Great Yarmouth Third River Crossing Order 202[*]

Document NCC/GY3RC/EX/064: Response to Written Submissions made by the Environment Agency at Deadline 5

Author: Norfolk County Council

Date: 11 February 2020

NCC/GY3RC/EX/064 - Figure 3

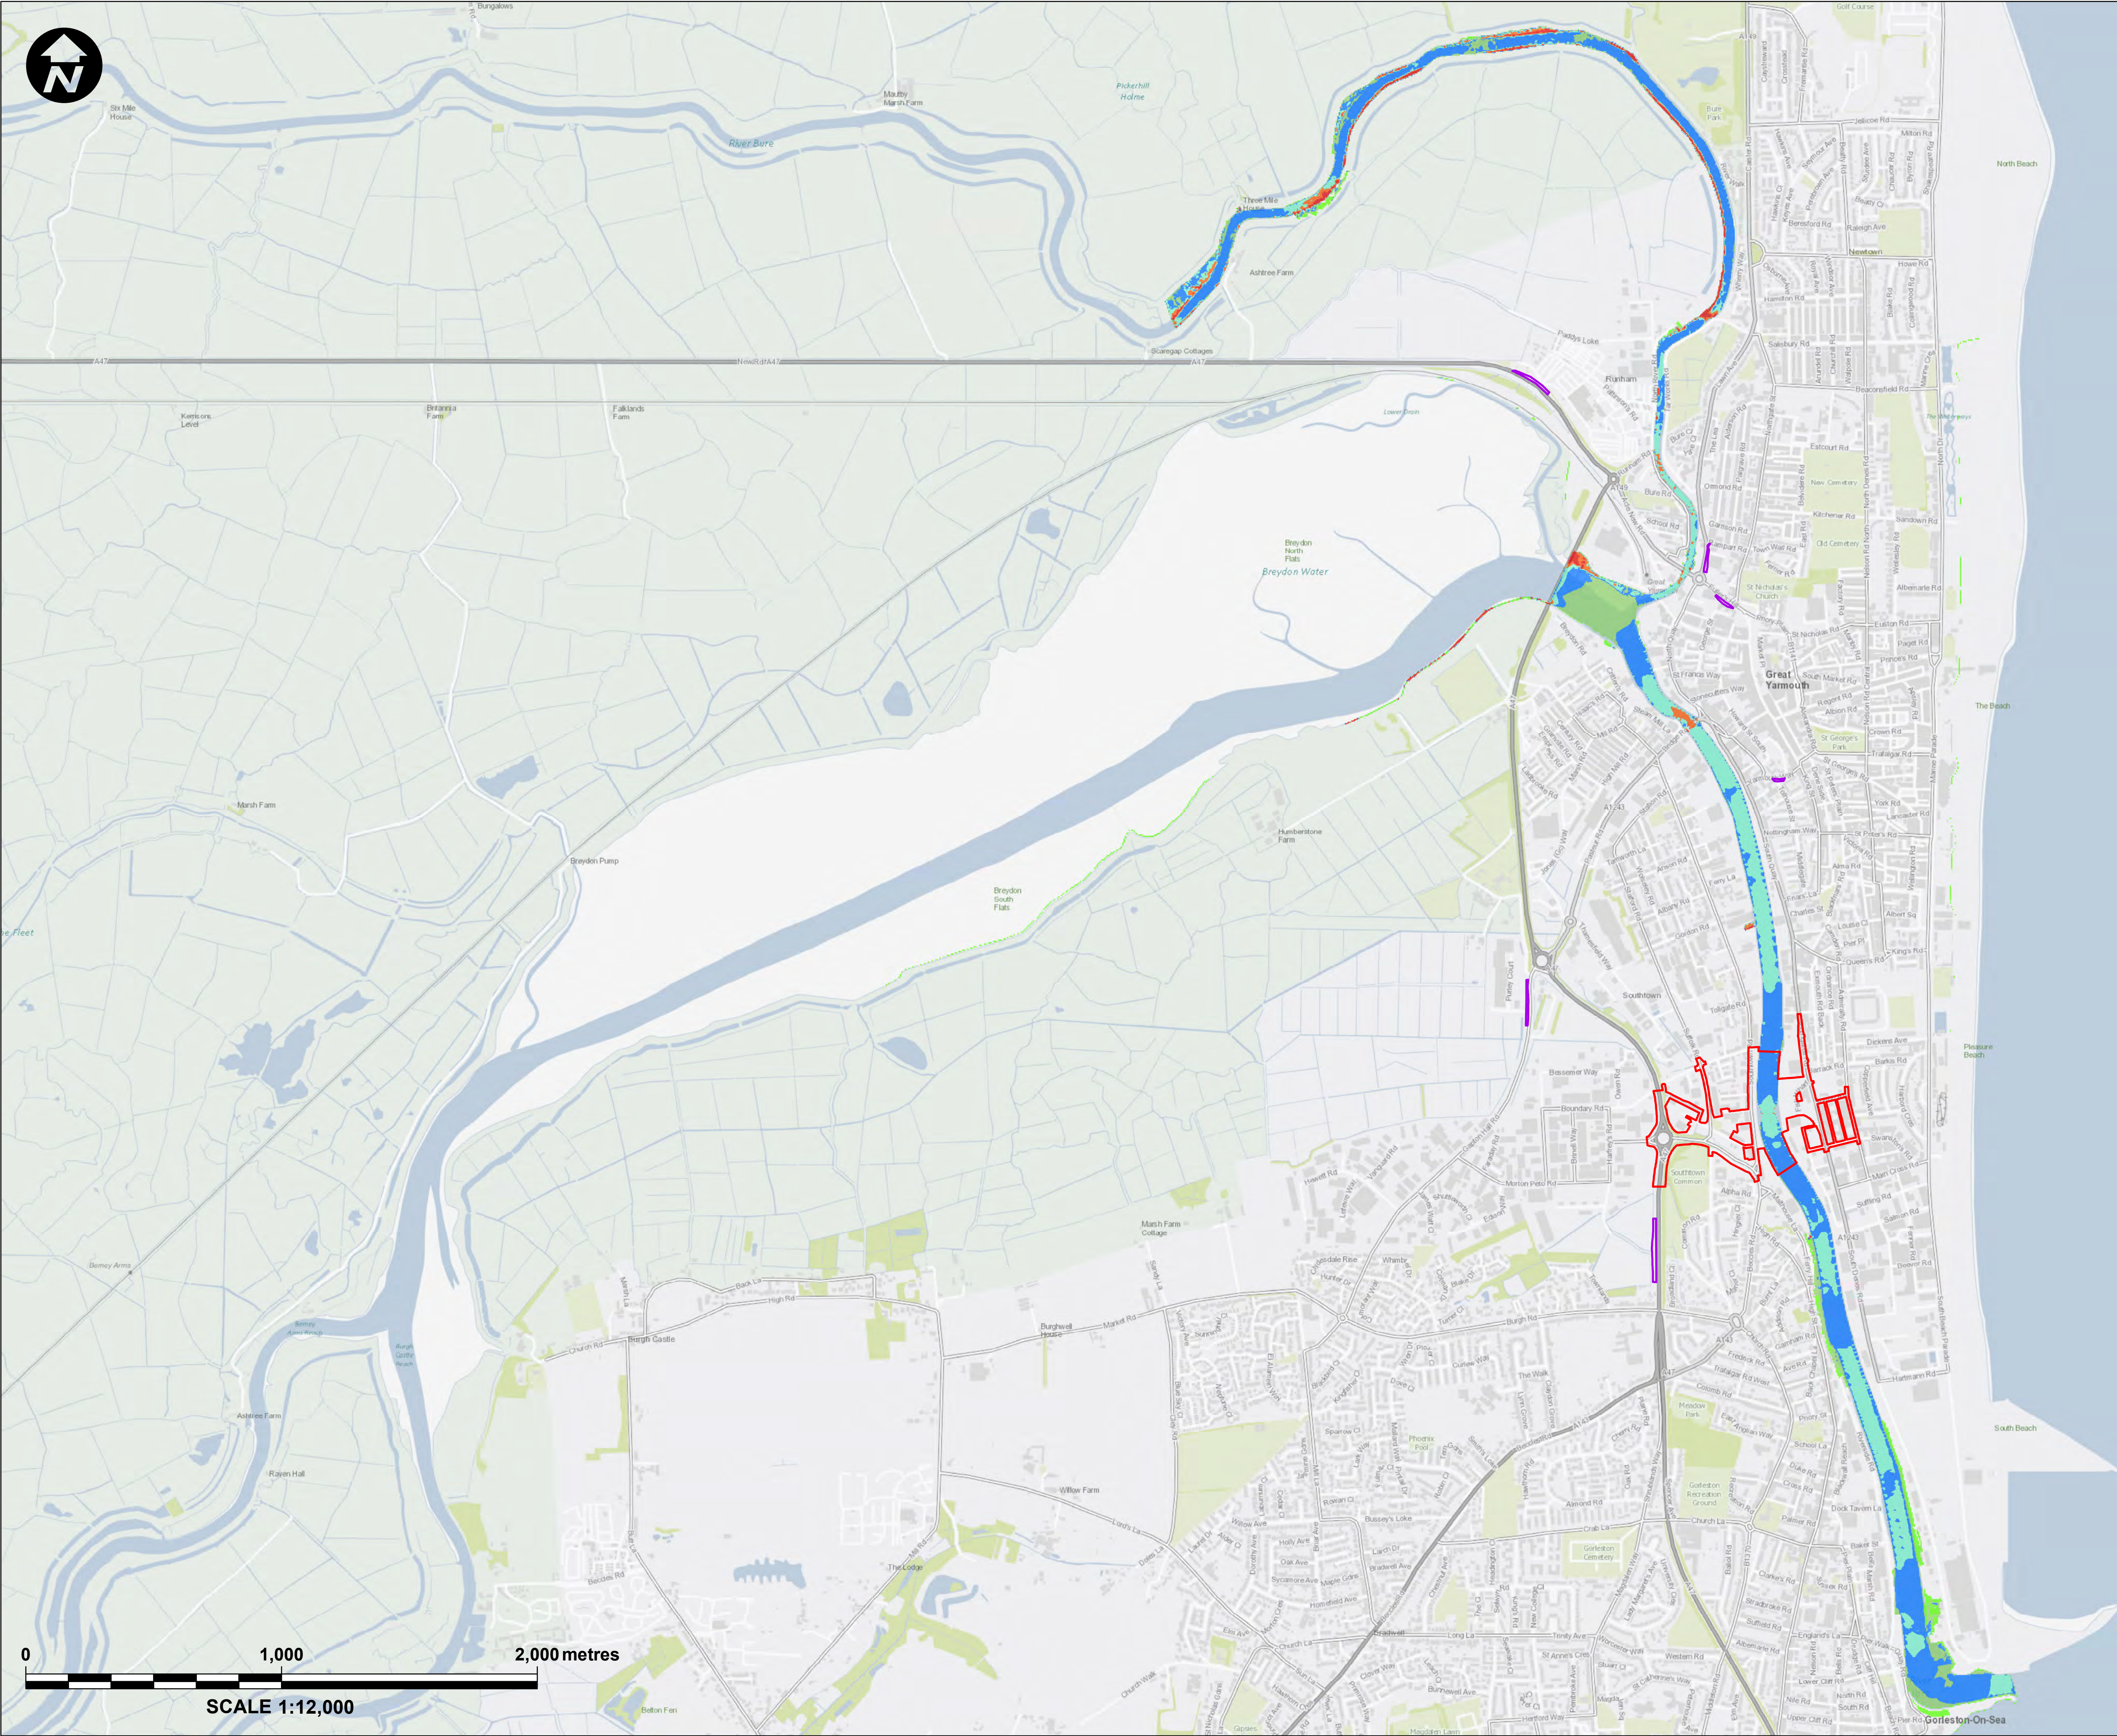
- 2.1.51 Section 6.2.45 of the FRA states that these in-channel changes for the 5% (1 in 20) AEP plus climate change event have less impact on the floodplain than the changes in the current day event. However, figure 12.8 shows that the baseline 5% (1 in 20) + AEP plus climate change event is flooding the floodplain, when the current day 5% (1 in 20) AEP event shows that the floodwater remains in channel. No figure has been provided showing the change in flood level or hazard on the floodplain for the 5% (1 in 20) AEP plus climate change event, so any change in risk in the floodplain is unknown.

2.1.56 The Applicant notes that the Environment Agency's interpretation of section 6.2.45 is not correct as the statement applies to all events not just the 5% AEP plus climate change. Figure 12.8 (Document Reference 6.3, Planning Inspectorate Reference APP-169) does confirm that the floodplain is inundated when climate change is added to all events. The depth and hazard maps are provided for the 0.5% and 0.5% plus climate change events with Document Reference 6.3, Planning Inspectorate Reference APP-169.

2.1.57 A set of figures showing the impact on flood risk for the 5% AEP event have been extracted from the hydraulic model and are presented in Appendix C. This set of figures has been requested by the Environment Agency. These figures show that the 5% AEP flows remain within the flood defences and that the scheme does not impact on the water levels. Therefore, they do not change the conclusions of the FRA (Document Reference 6.2, Planning Inspectorate Reference APP-135) and are provided for clarification purposes only.
